SAVAGE SUBDIVISION – PRELIMINARY PLAT

900 W 85 SOUTH

CITY COUNCIL MEETING

FEBRUARY 2, 2023

C302

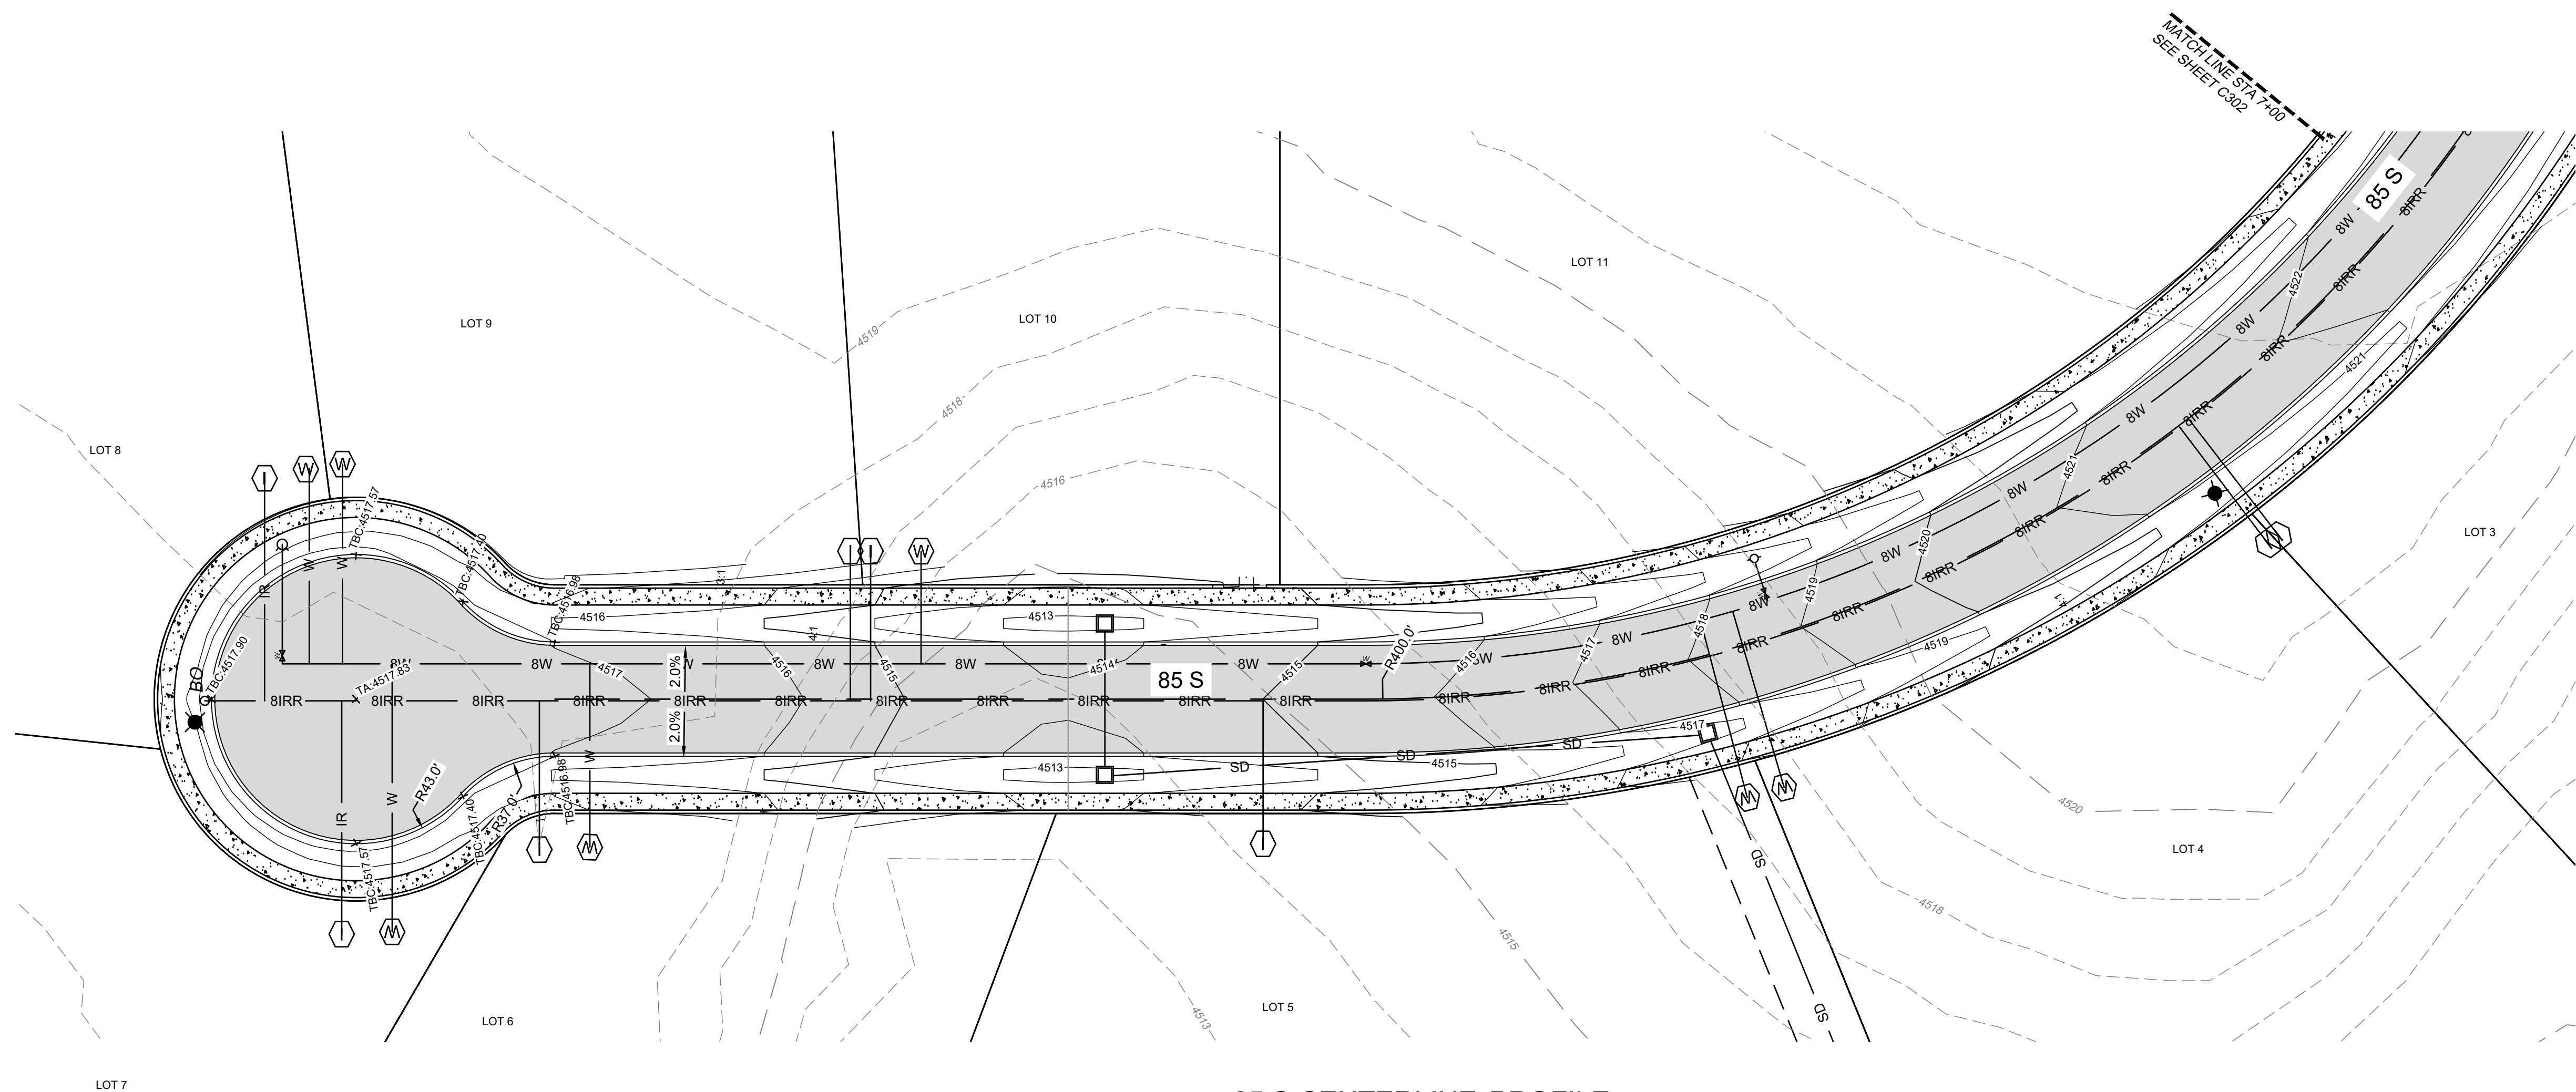
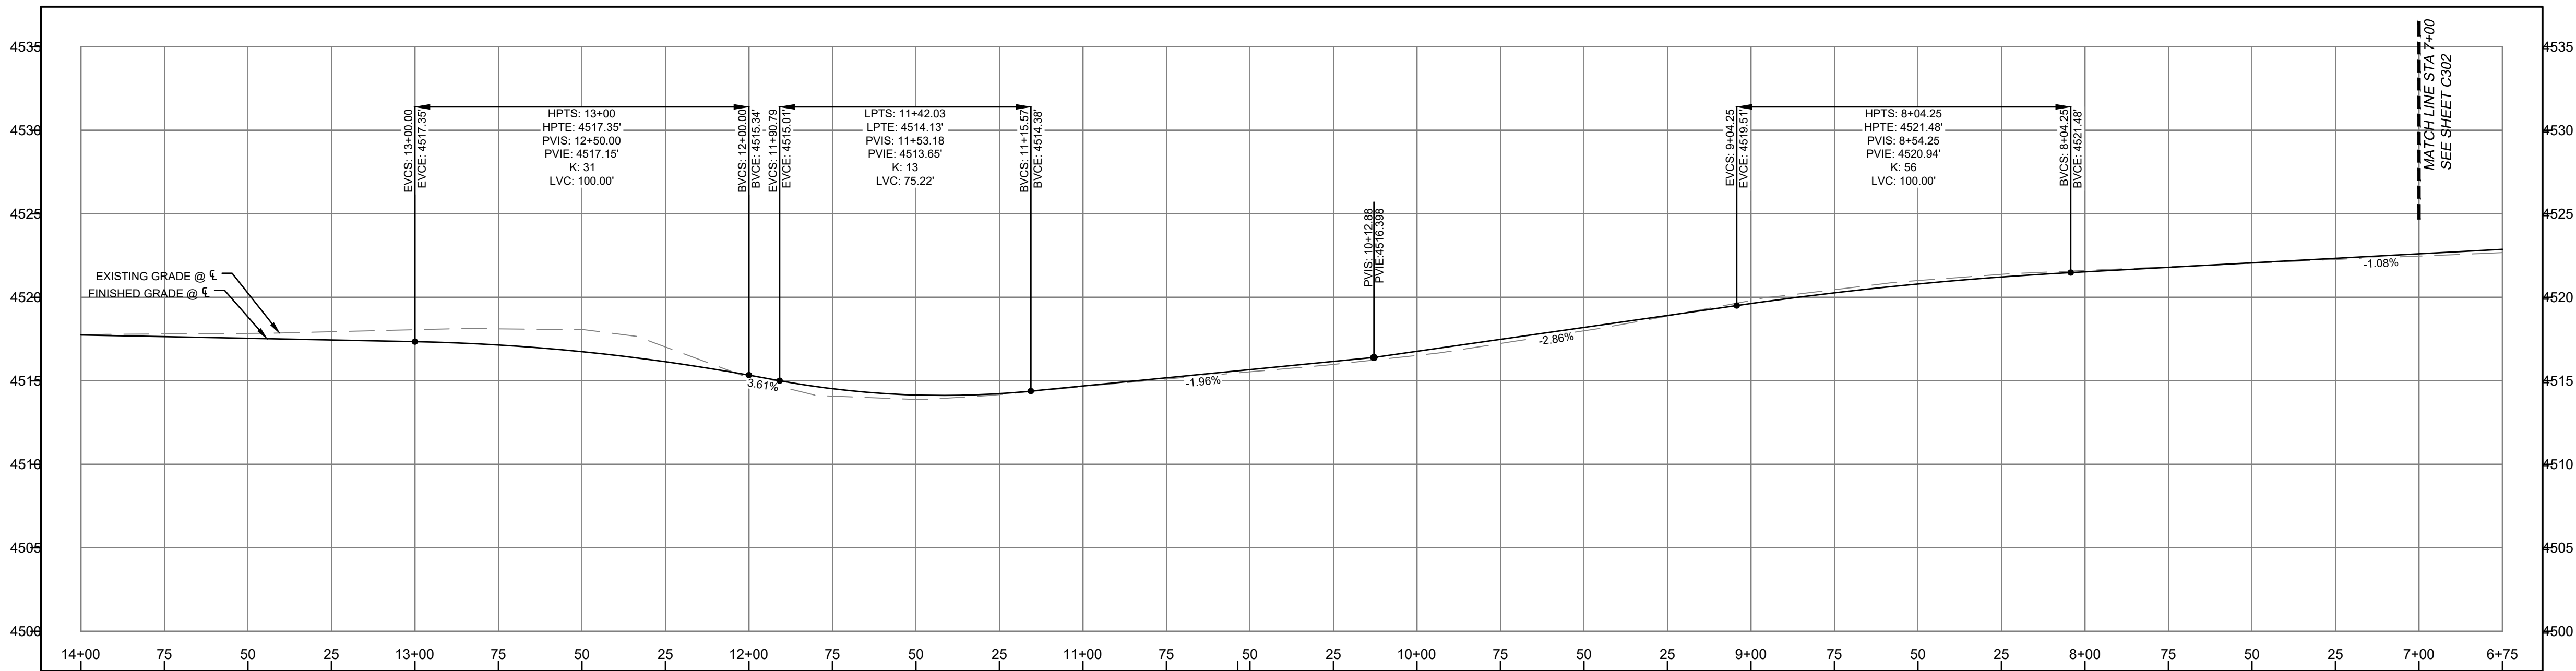
OWNERSHIP OF PARCEL A/ MAINTENANCE

UTILITY CONNECTION? POWER FOR FLAGPOLE AND SIGN?

FENCING/GATE OVER CANAL AND BRIDGE

C801

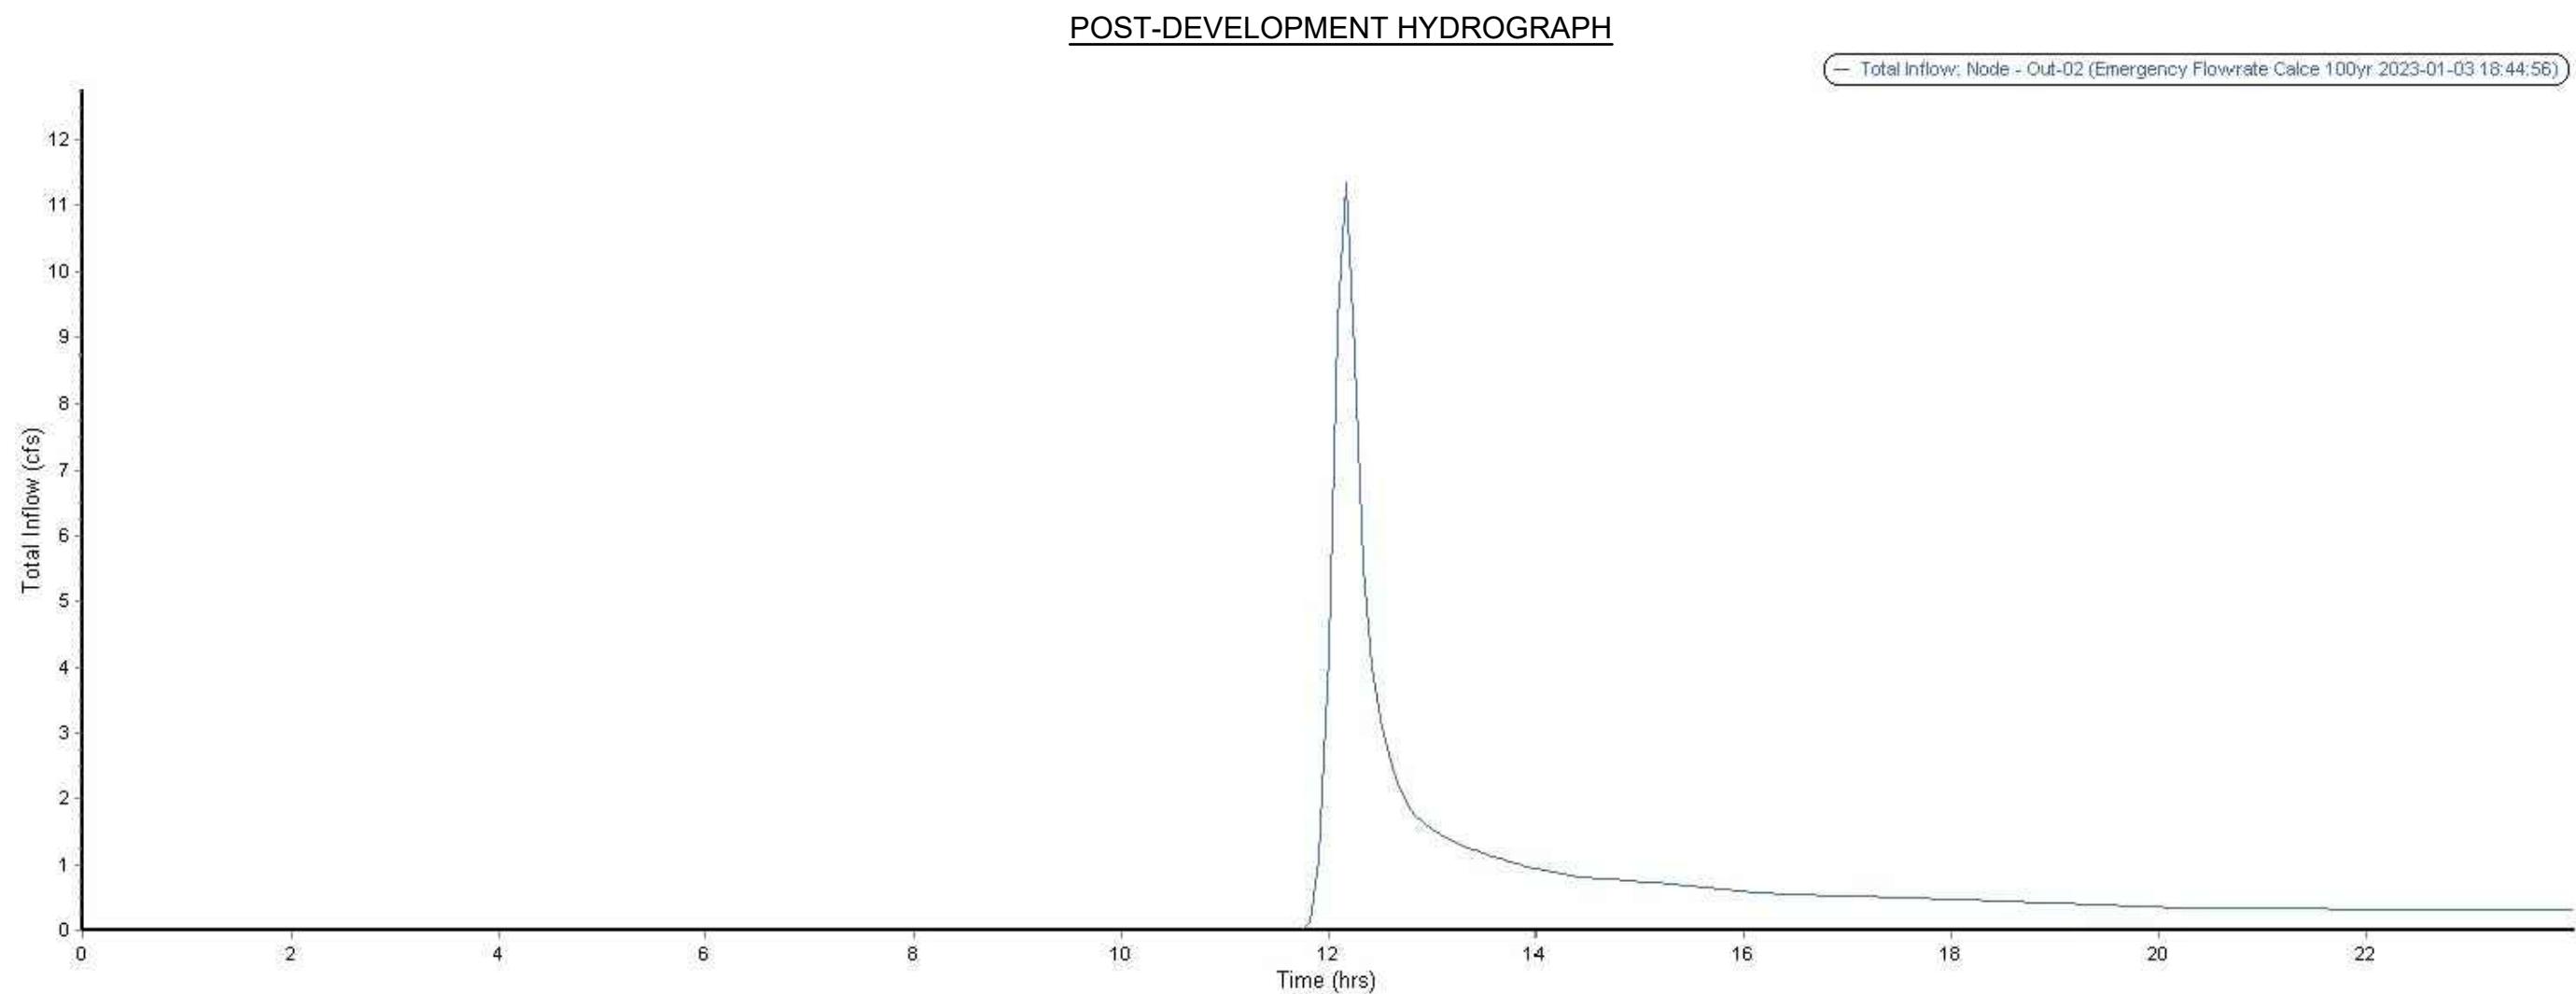
SWALES ARE ALMOST ENTIRELY IN SLOPE. HOW IS STORAGE TO BE OBTAINED? DRIVES ARE TO BE ASSUMED AS CHECK DAMS, BUT DO NOT APPEAR TO DETAIN ENOUGH WATER. IF A FLASH STORM HITS, WHAT IS THE EMERGENCY FLOW PATH?
